Access Compliance Report Public Rights-of-Way (Curb Ramps)

Main Street: CECIL_PASTURE_RD		Cross Street: N/A		Location:	N
ADA ID: RPRK211026122949	Ramp Type: Type 4 - Parallel	Initial Pass/Fail: Fail	Overall Compliance: No	Severity Score:	15
Codes/Mitigation Info/Possible Solution			Field Measurements/Component Compliance

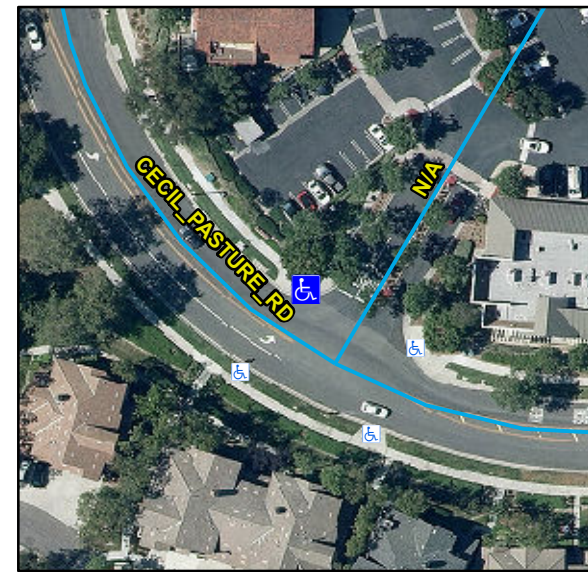
Compliance	Description	Data	Compliance	Description	Data
N/A	Ramp Length LT (in)	107	N/A	Ramp Length RT (in)	107
Yes	Ramp Width LT (in)	90	Yes	Ramp Width RT (in)	90
Yes	Ramp Run Slope LT (%)	1	Yes	Ramp Run Slope RT (%)	6.1
No	Ramp Cross Slope LT (%)	4.2	No	Ramp Cross Slope RT (%)	6.3
N/A	Landing Present	N/A	N/A	DWS Provided	N/A
N/A	Landing Length (in)	N/A	N/A	DWS Contrast	N/A
N/A	Landing Width (in)	N/A	N/A	DWS Length (in)	N/A
N/A	Landing Run Slope (%)	N/A	N/A	DWS Full Width	N/A
N/A	Landing Cross Slope (%)	N/A		DWS Offset Type	N/A
N/A	Landing Movement Obstructed?	N/A	N/A	DWS Offset Left (in)	N/A
	Landing Movement Type	N/A	N/A	DWS Offset Right (in)	N/A
N/A	Landing Shared	N/A			
N/A	Clear Space	Yes			
N/A	Clear Space To Crosswalk (in)	N/A			
N/A	Marked Crosswalk 1	No	N/A	Marked Crosswalk 2	No
	Crossing 1 Direction	SW		Crossing 2 Direction	SE
	Marked Crosswalk 1 Width (in)	N/A		Marked Crosswalk 2 Width (in)	N/A

Remove & Replace Curb Ramp With Two New Directional Ramps or Equivalent.
